**PARK CITY BOARD OF ADJUSTMENT MEETING  
SUMMIT COUNTY, UTAH  
June 18, 2024**

6.A. **1014 Empire Avenue** - The Applicant Requests a Variance From the Requirements of Land Management Code Section 15-3-8 Regarding Materials for a Non-Historic Single-Family Dwelling in the Historic Residential - 1 Zoning District.  
PL-24-06114  
(A) Public Hearing; (B) Action

# Board of Adjustment Staff Report

**Subject:** 1014 Empire Avenue  
**Application:** PL-24-06114  
**Author:** Planning Team  
**Date:** June 18, 2024  
**Type of Item:** Variance

The image below is taken from the Applicant's west elevation, the plans submitted as part of the HDDR Application, showing a compliant front door and solid garage doors:

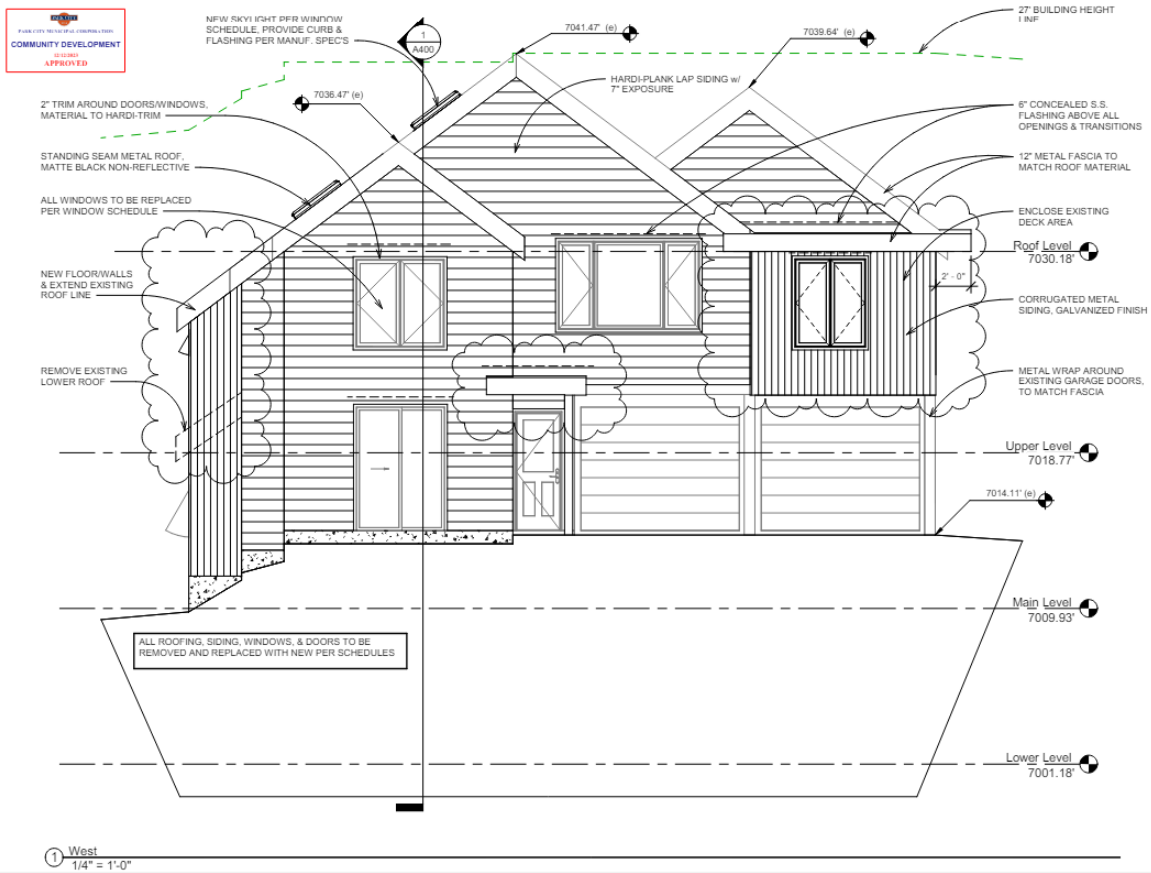
The HDDR Condition of Approval 1 states “[f]inal building plans and construction details shall reflect substantial compliance with the plans approved August 19, 2021, by the Planning Department. Any changes, modifications, or deviations from the approved design that have not been approved in advance by the Planning and Building Departments may result in a stop work order.”

② West w/ Glass Doors  
1/4" = 1'-0"

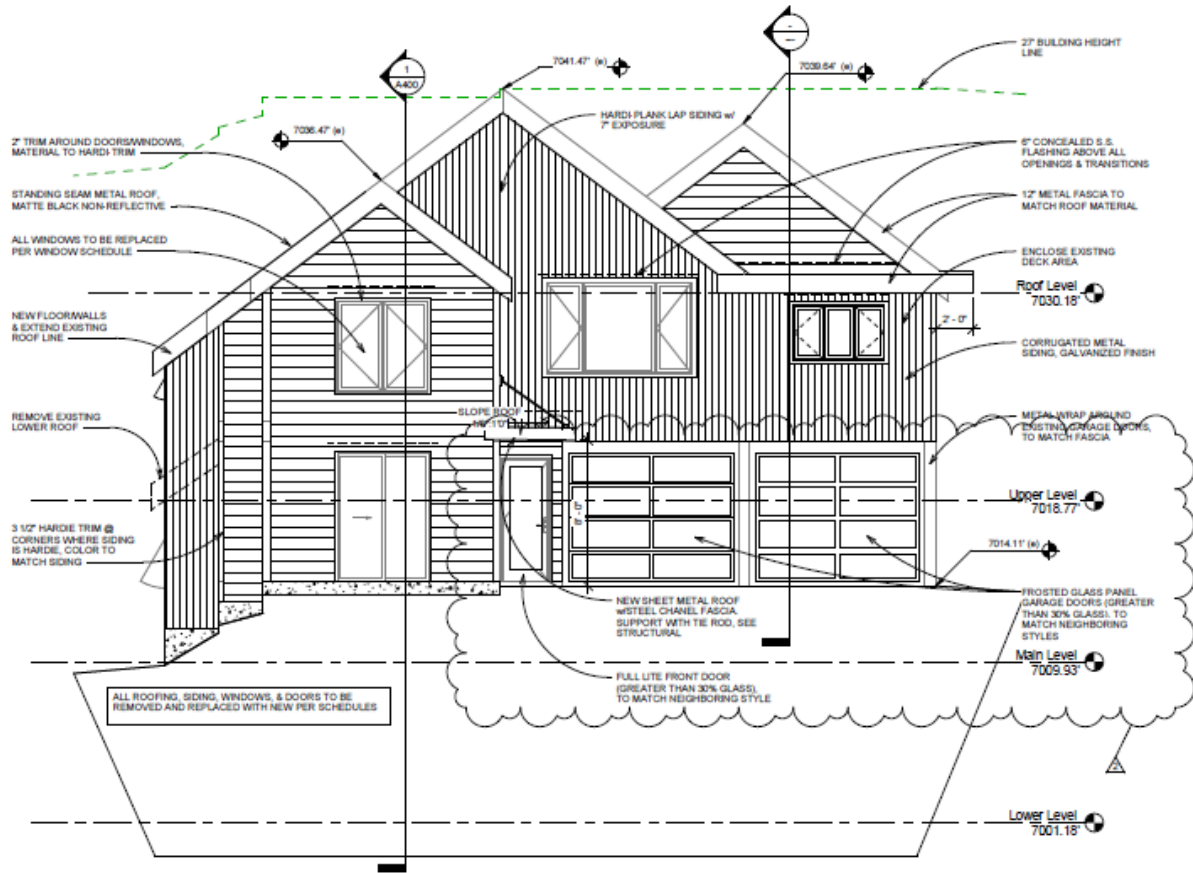
At some point during construction, the Applicant modified the front door and garage doors without review or approval, contrary to approved Building Permit 21-1332, the HDDR Conditions of Approval, and the requirements of LMC [Section 15-13-8](#). In December 2023, the Applicant’s Representative requested a final inspection to close the Building Permit. During the inspection, Planning staff noted that the front door and garage doors installed were not compliant with Building Permit 21-1332, the HDDR Conditions of Approval, and the requirements of LMC [Section 15-13-8](#). Specifically, the glazing exceeded 30%, and the garage doors contained frosted glass.

12. At some point during construction, the Applicant modified the front door and garage doors without review or approval, contrary to the LMC and the HDDR Conditions of Approval.

13. In December 2023, the Applicant’s Representative requested a final inspection of the remodel to close the Building Permit. During the inspection, Planning staff noted that the front door and garage doors installed were not compliant with LMC Section 15-13-8. Specifically, the glazing exceeded what is allowed, and the garage doors contained frosted glass.

Building and Planning staff and the Applicant established a timeframe for the Applicant to bring the front door and garage doors into compliance Building Permit 21-1332, the HDDR Conditions of Approval, and the requirements of LMC [Section 15-13-8](#) and allowed the Applicant up until May 1, 2024, to install compliant doors. However, the Applicant did not install code-compliant doors. Rather, on May 2, 2024, the Applicant submitted a Variance application, requesting the Board of Adjustment grant a Variance for the Applicant to keep the non-compliant doors. Please see Exhibit B to review the Applicant’s statement.
